UNITED STATES PATENT AND TRADEMARK OFFICE

APPLICATION NO.	FILING DATE	FIRST NAMED INVENTOR	ATTORNEY DOCKET NO.	CONFIRMATION NO.
10/769,370	01/30/2004	Lloyd E. Andrews	2065/US/2	7913

Office Action Summary

DETAILED ACTION

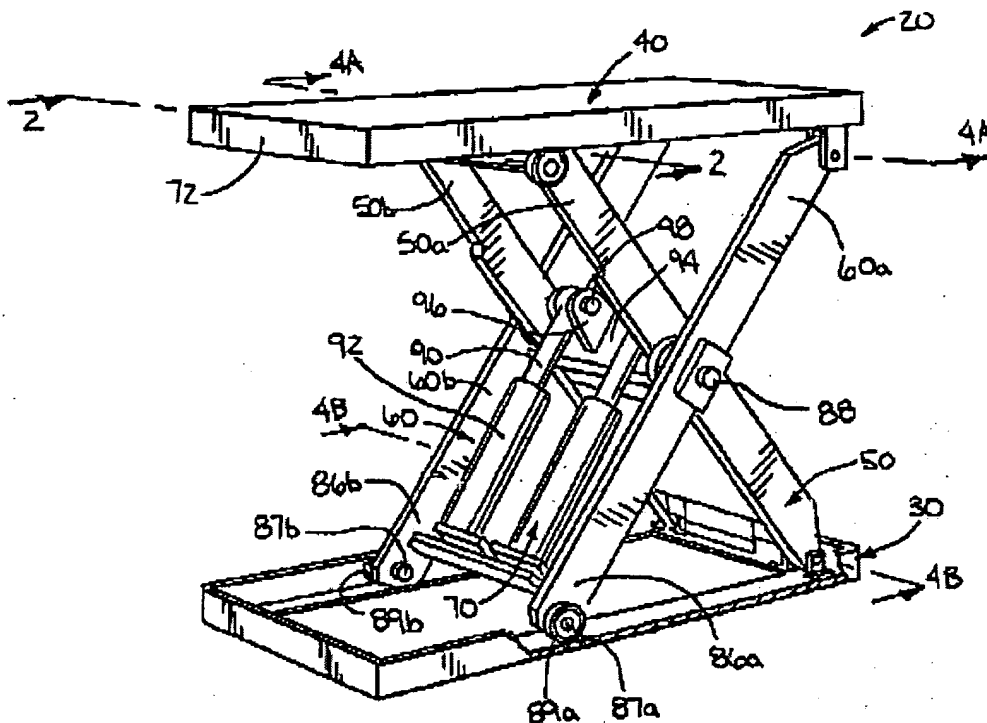
- a. Figure 30 shows scissor jacks 140 of trailer 124 in the extended position. Addressing the scissor jack in the front right of the figure, the lower end of the scissor jack cross member closest to the wheel 144 is fixed to the trailer, while the lower end of the other associated cross member is slideably engaged in track 172 of rail 170 atop bottom frame member 136. Both top ends of the cross members are fixed to top frame member 138, and there is no track 172 on the underside of top frame 138. The other sets of scissor jacks depicted are similarly secured. The scissor jack is immobile in this position and cannot move to the retracted position. In other words, the device is inoperable.

- b. In addition, please note, rail 172 can be seen atop bottom frame member 136 in figures 3, 4, 7, 10, 11, 13, 15, and 31. If a second rail 172 were mounted to the lower side of top frame member 138, it would be visible in these figures (the absence is most conspicuous in the last three figures listed).

- c. Paragraph 77 of the specification states "Since each scissor jack 140 has its own track 172 permitting free movement of the un-pinned ends, as shown in more detail in FIG. 25, each scissor jack can collapse to its retracted position without interfering with the other scissor jacks" [underlining added for emphasis]. In order to be operative, each scissor jack would require its own pair of tracks 172 (upper and lower) vice the track (singular) recited in the specification.

- d. Below is an example of a scissor jack taken from US 6,974,123 B2 (Latvyns) show only to illustrate a functional version of a similar scissor jack. Please note the sliding connection on both the lower and upper surfaces.

- e. No new matter should be entered.
